Item Name: Crosstube Turning Detail

DART AEROSPACE LTD	Work Order: 401365
Description: Crosstube Assembly (205/212/412 High Fwd)	Part Number: D212-664-141
Inspection Dwg: D212-664-141 Rev: D	Page 1 of 2

DRAWING NO. D212-664-141	TITLE XTUBE ASSY (205/212/412 HI FWD)	REV. D	DART AEROSPACE LTD ENGINEERING ORDER		D.E.O. NO. D212-664-141-D-1	SHEET NO. SHEET 1 OF 2	SCALE NTS
DRAWN	CHECKED	MFG. APPR.	APPROVED	DE APPR.			
DATE 11.04.07	DATE 11.07.11	DATE 11.04.12	DATE 11/04/12	DATE 11.04.12

ADD AN INSPECTION WINDOW TO UNDERSIDE OF CROSSTUBE.

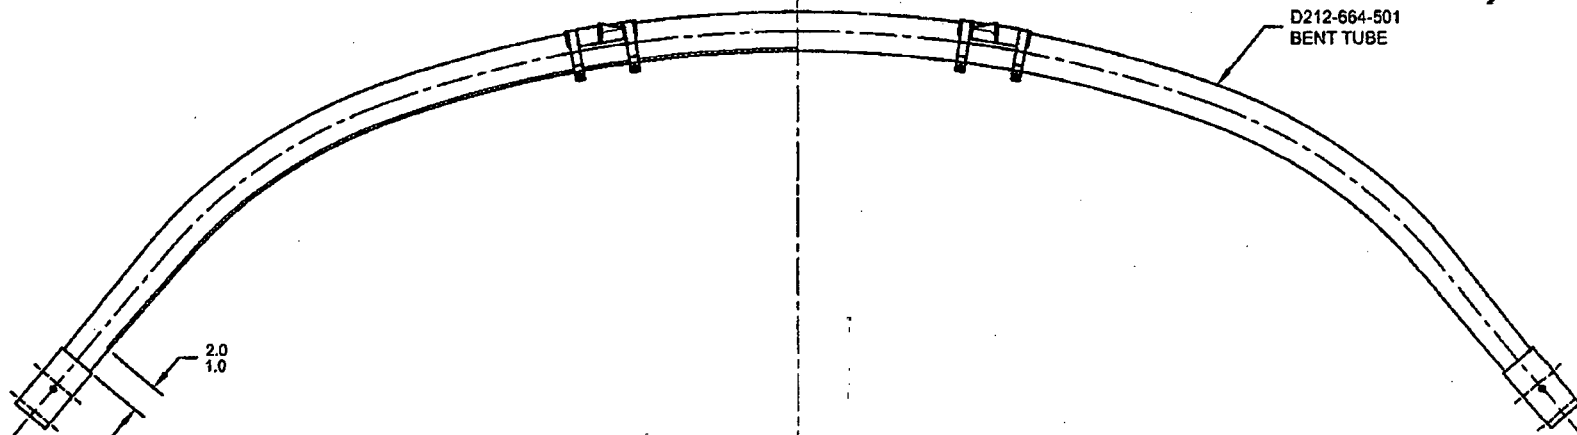
- 2) FINISH: CHEMICAL CONVERSION COAT PER DART QSI 005 4.1
PRIME INSIDE AND OUTSIDE PER DART QSI 005 4.2
MASK UNDERSIDE OF CROSSTUBE AS SHOWN (HATCHED AREA) AND
PAINT OUTSIDE PER DART QSI 005 4.2
REMOVE MASKING AND APPLY CLEAR COAT

- 2) FINISH: CHEMICAL CONVERSION COAT PER DART QSI 005 4.1
PRIME INSIDE AND OUTSIDE PER DART QSI 005 4.2
PAINT OUTSIDE PER DART QSI 005 4.2

MASK AREA PRIOR TO PAINTING.
REMOVE MASKING AFTER PAINT
AND APPLY CLEAR COAT
